Re: Maider Road Waterfront Site

Site ID No. B00015

We have received your letter dated March 2, 2016 regarding the Department's comments to our Supplemental Investigation / Alternatives Analysis Report, dated December 2015 for the above referenced site. Our responses to Department comments are provided below. Department comments are shown below in italics, while C&S comments and clarifications are shown in bold.

FIGURE 4

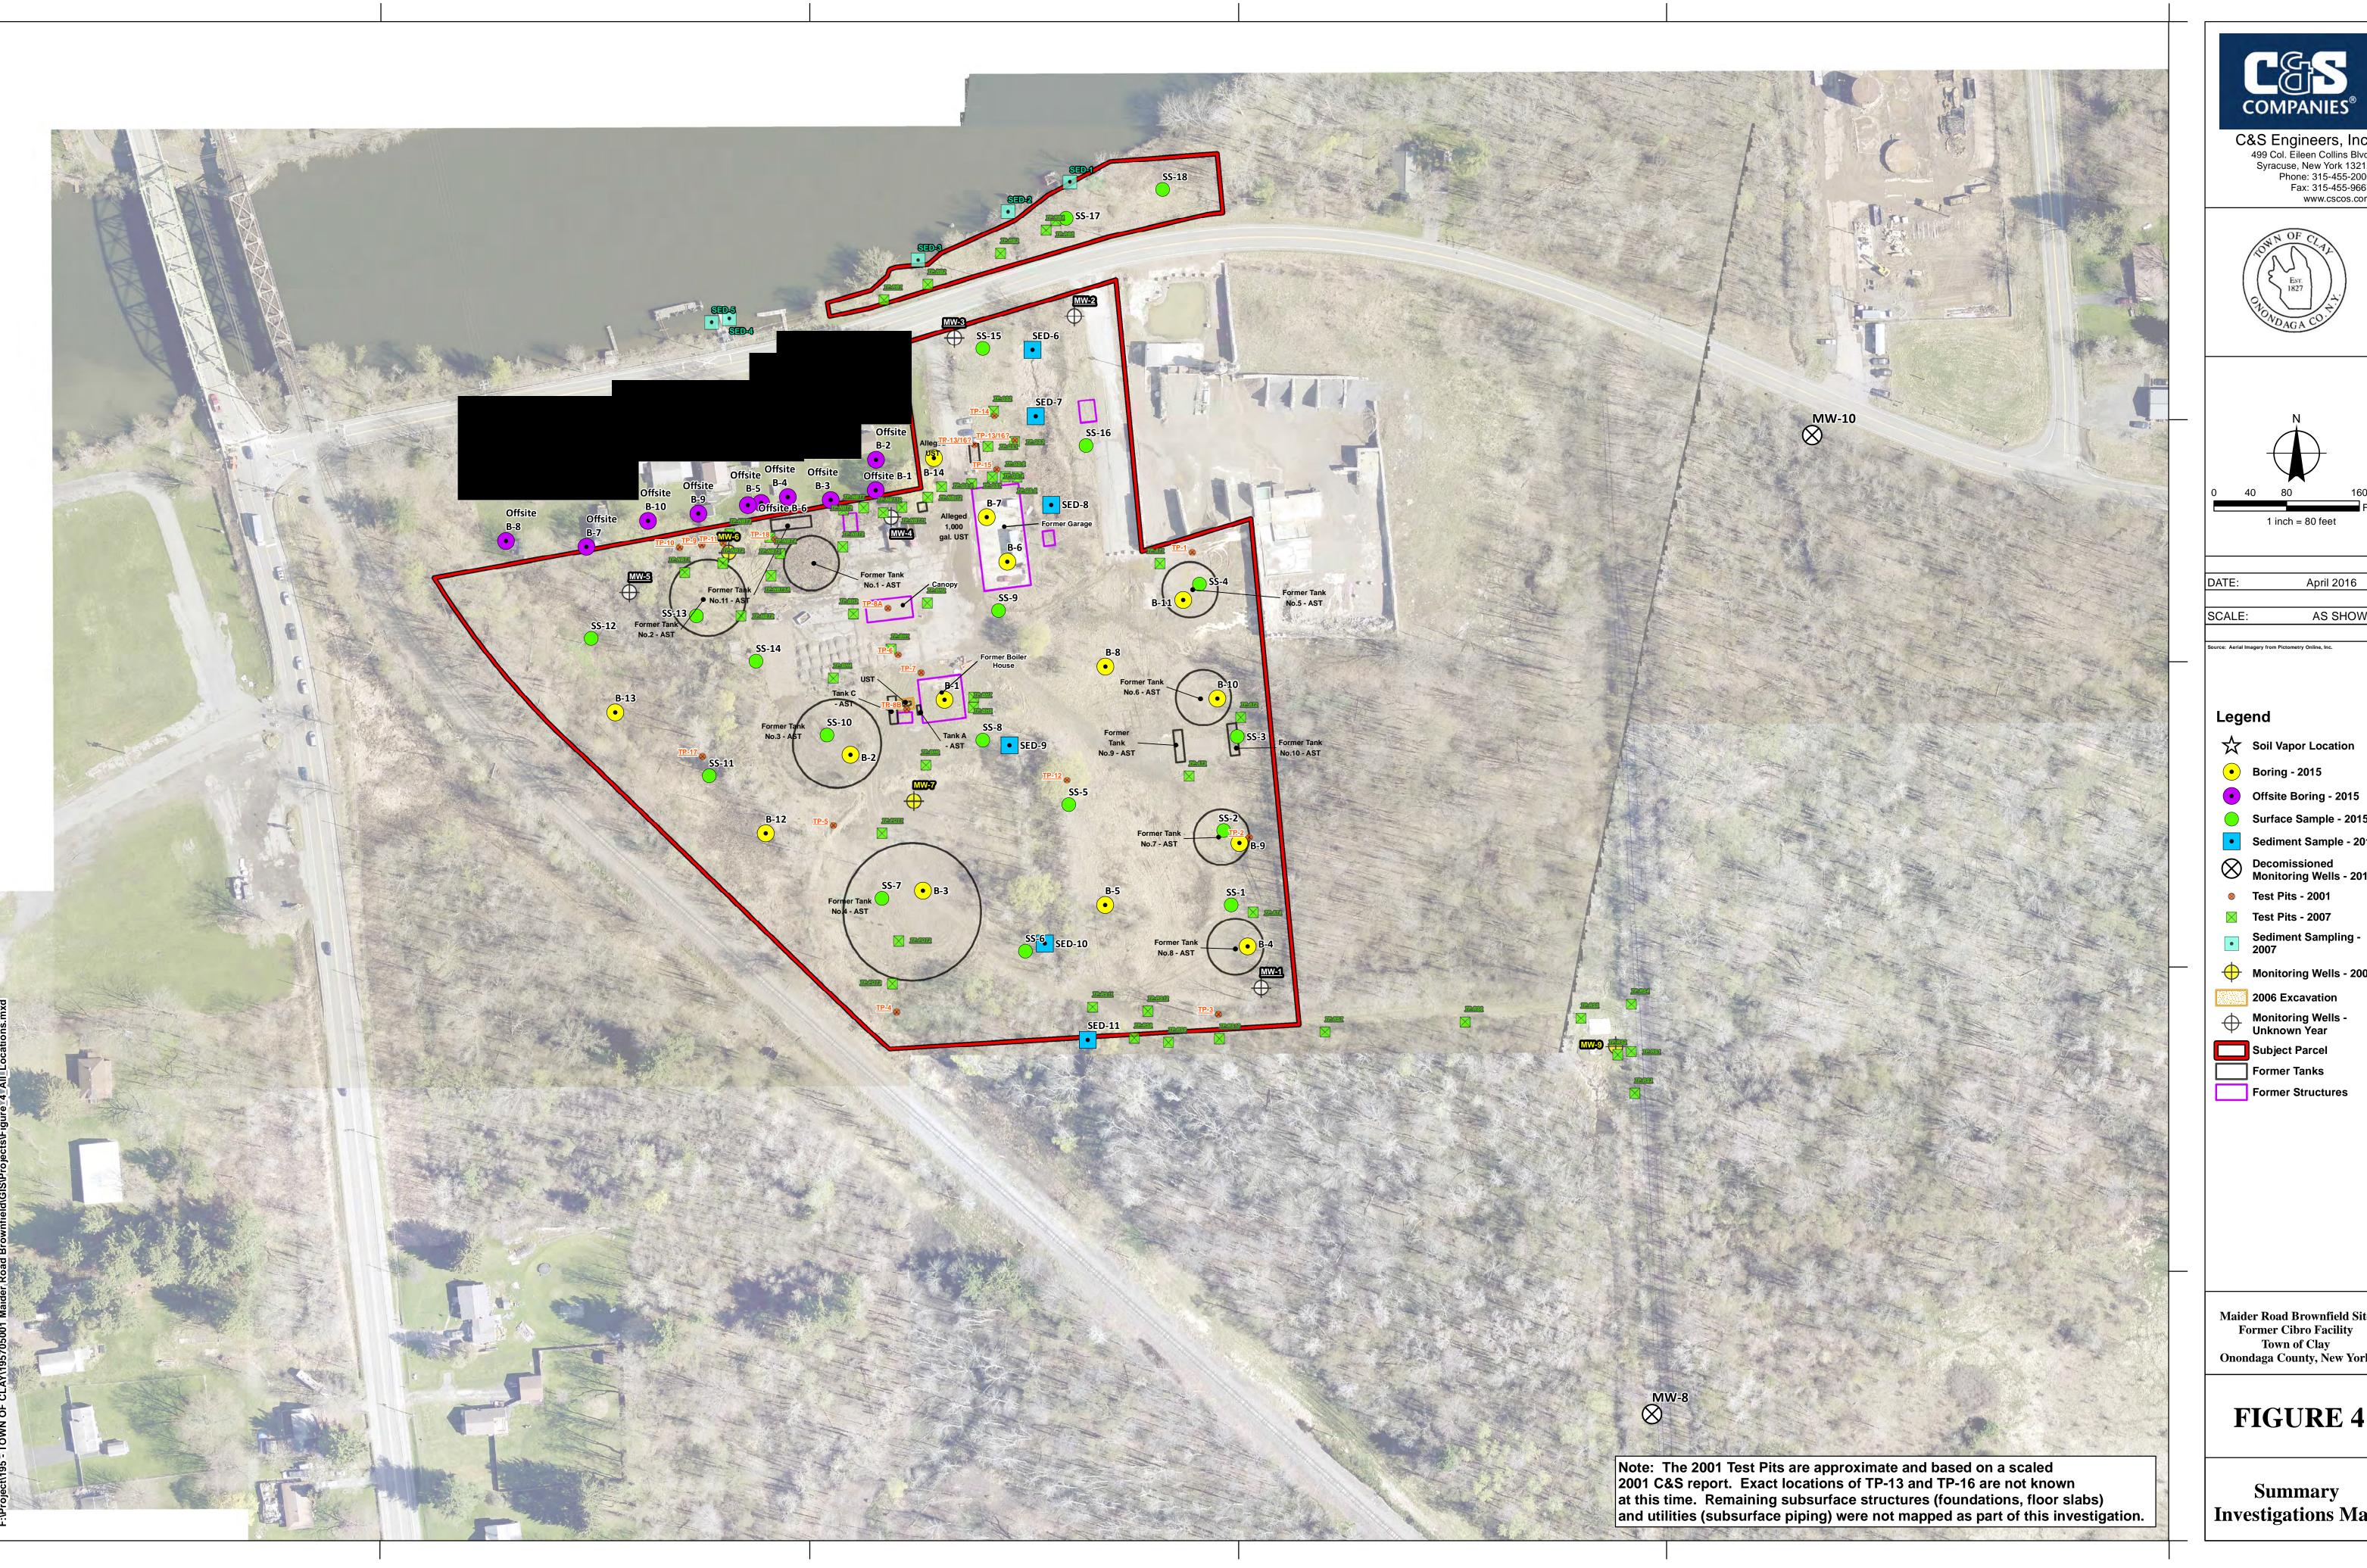
Comment 4: Figures 2 & 4 – Please make the following corrections and resubmit:

- a. Based on the field notes in Appendix A, TP-9 should be located between TP-10 and TP-11. Figures 2 & 4 were updated accordingly.
- b. TP-NBT10, TP-RB2, TP-RB3 and TP-RB5 are missing. These test pit locations were added to Figure 2 & 4
- c. According to previous reports, the tank labeled as Tank 9 is actually Tank 10, and the tank labeled as Tank 10 is actually Tank 9. This correction must be made to Figure 3 as well. Figures 2, 3, and 4 were updated accordingly.
- d. Test pits TP-13 through TP-16 should be labeled as they were in the 2002 report. It is not clear which is which; however, based on the field notes in Appendix A, it seems unlikely they are labeled correctly on these figures. Alternatively, submit an explanation how it was determined which test pit was which.

Comment 5: Figures 3 & 4 – The boring labeled as "Off-site B-2" should be "Off-site B-1"; "Off-site B-3" should be "Off-site B-2"; and "Off-site B-1" should be "Off-site B-3". Please make the corrections and resubmit.

Response: We have made the corrections on Figures 2, 3, and 4. The amended figures are attached. Please note the exact locations of TP-13 and TP-16 could not be verified. Field notes indicate soils were similar and both exhibited petroleum odor.

Response: We have relabeled the borings on Figures 3 & 4. The amended figures are attached.

FIGURE 5

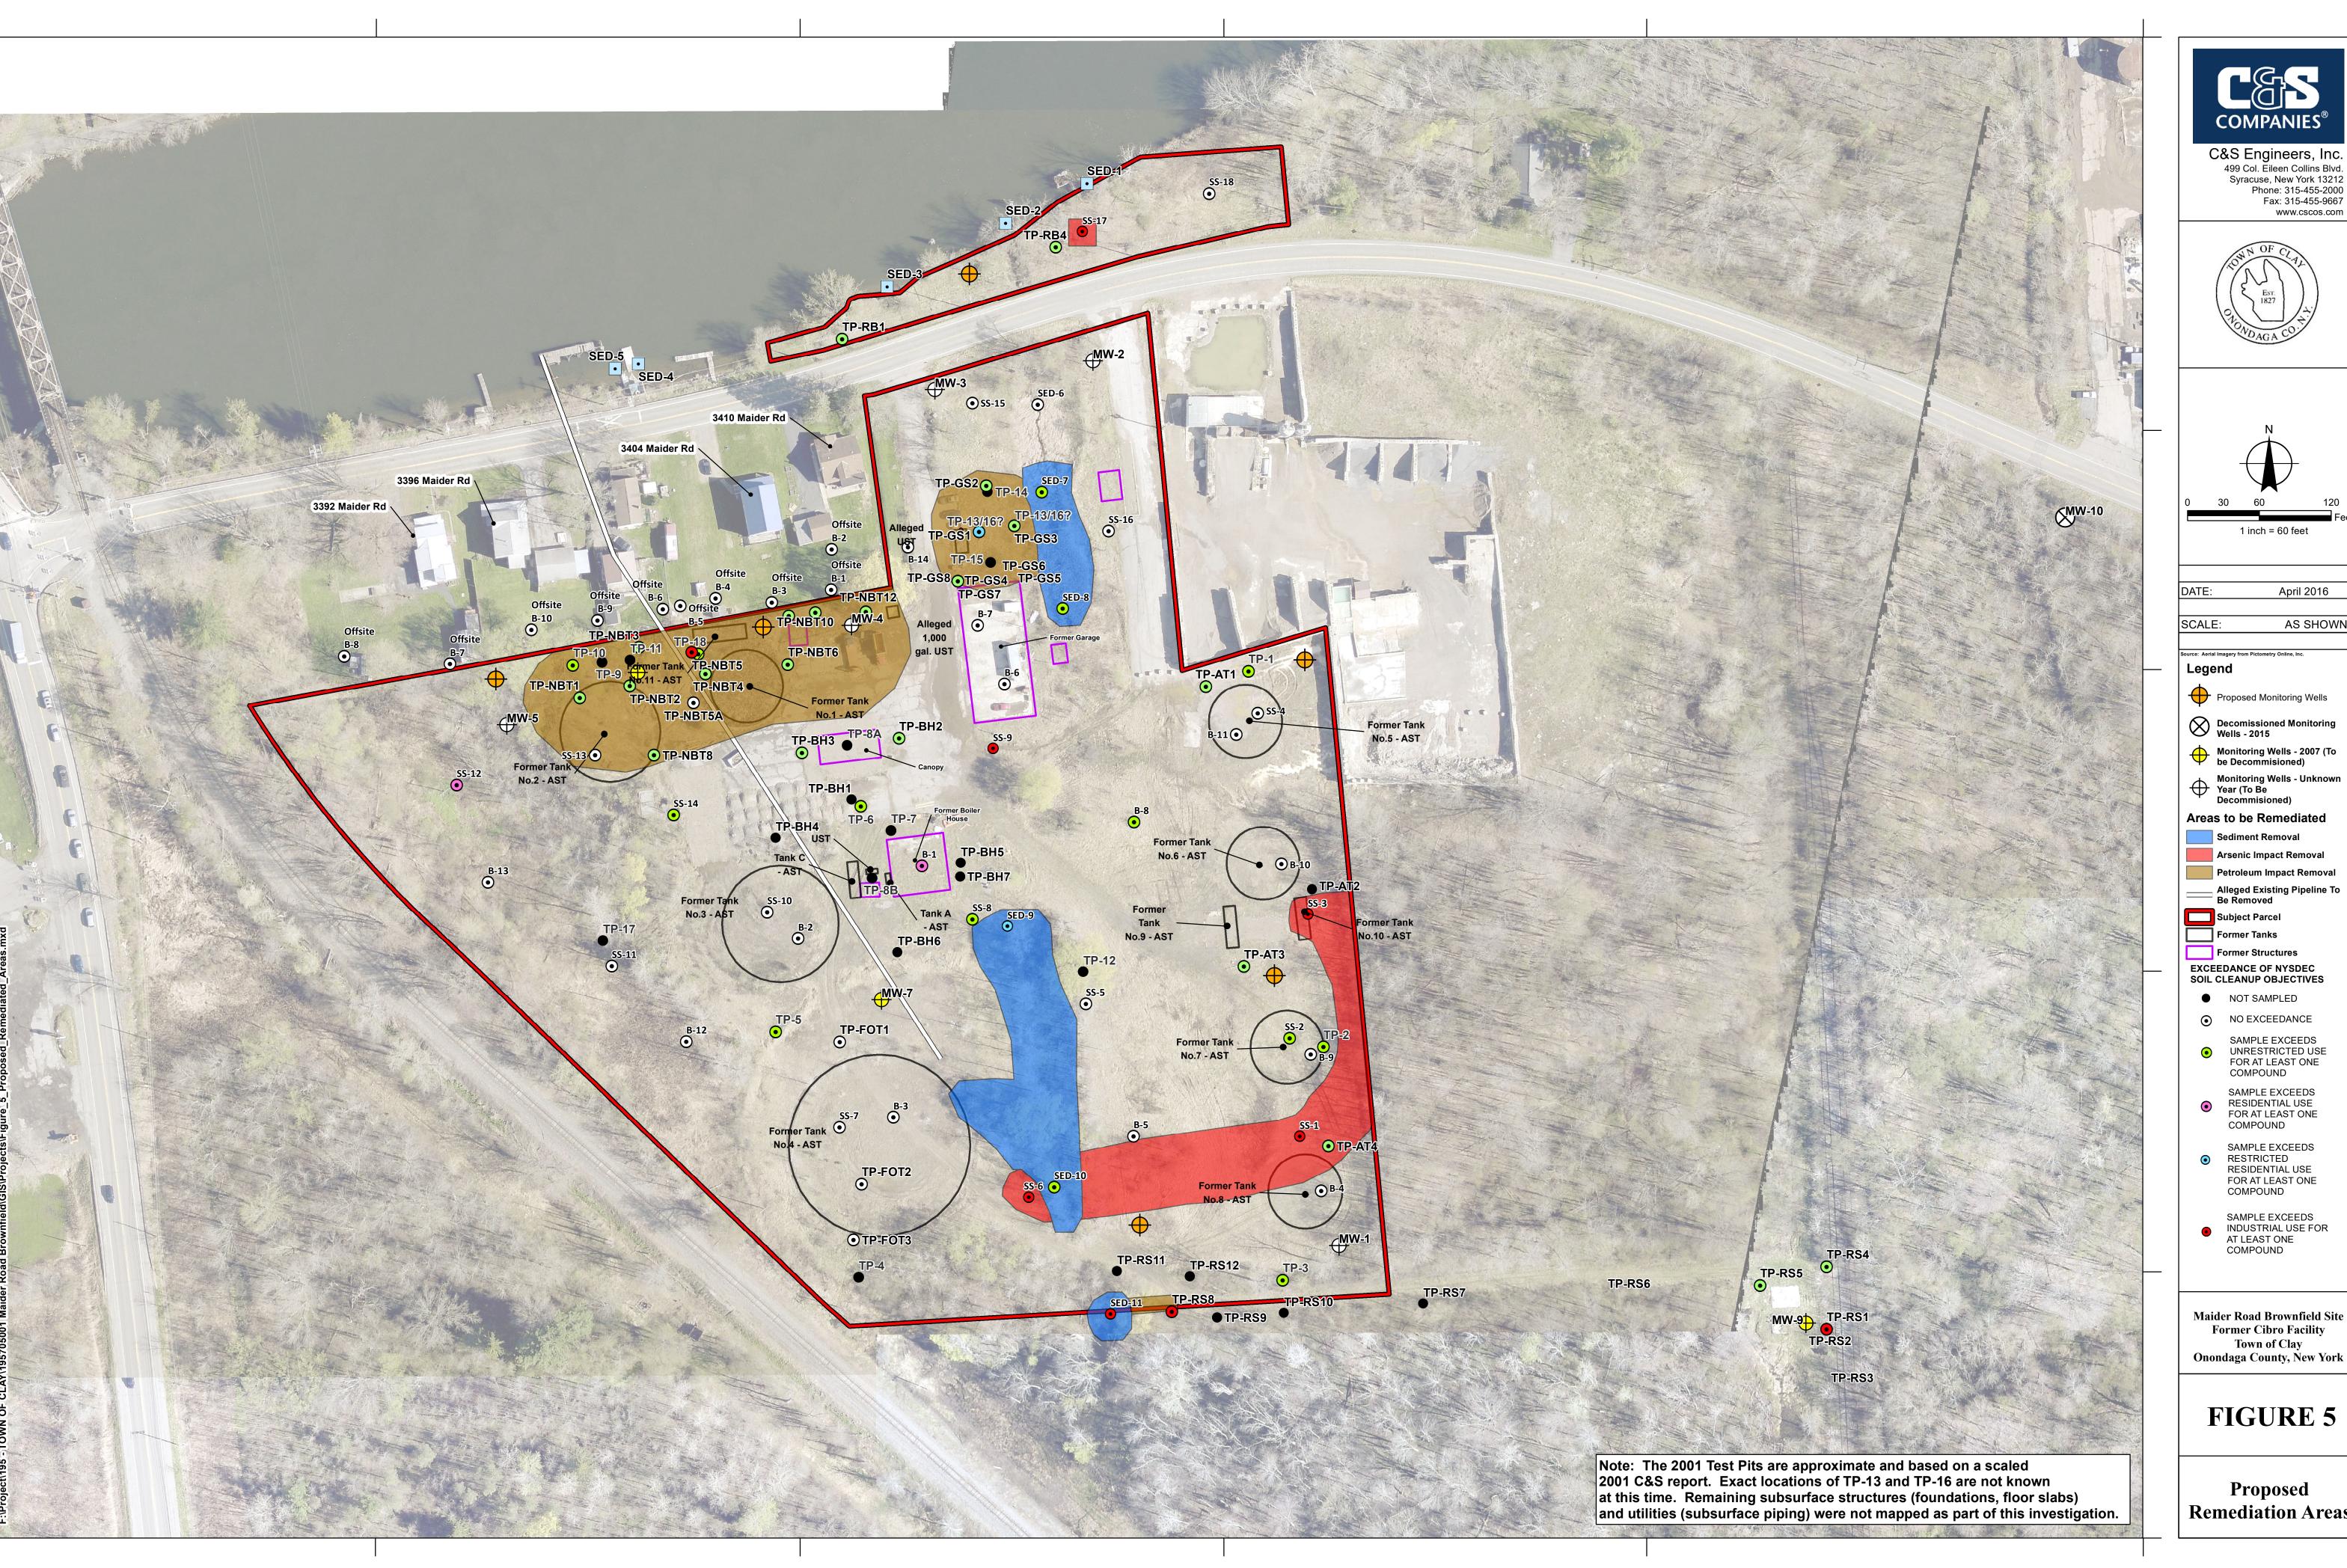
Comment 3: Figures – Submit a figure or figures depicting the areas to be remediated for each alternative.

The additional information required by this letter must take into account the need for groundwater monitoring. The figures submitted depicting the areas to be remediated must include some preliminary/conceptual locations for monitoring wells upon completion of the excavations. The cost estimates must include the cost of installing sufficient monitoring wells, including upgradient and downgradient wells for each area of impact, and must include the cost of groundwater monitoring as part of the annual costs.

Response: The areas to be remediated for each alternative are attached as Figures 5.

Response: Section 9 has been updated to include the RAO's for groundwater. In addition, Sections 10 and 11 have been updated to include long-term groundwater monitoring as an alternative to compliment the soil Restricted Residential Use Alternatives that include partial soil removal and / or treatment. Costs for groundwater monitoring are shown in Tables 9 and 10. Figure 5 shows the locations of the existing wells to be decommissioned as well as the proposed new well network.
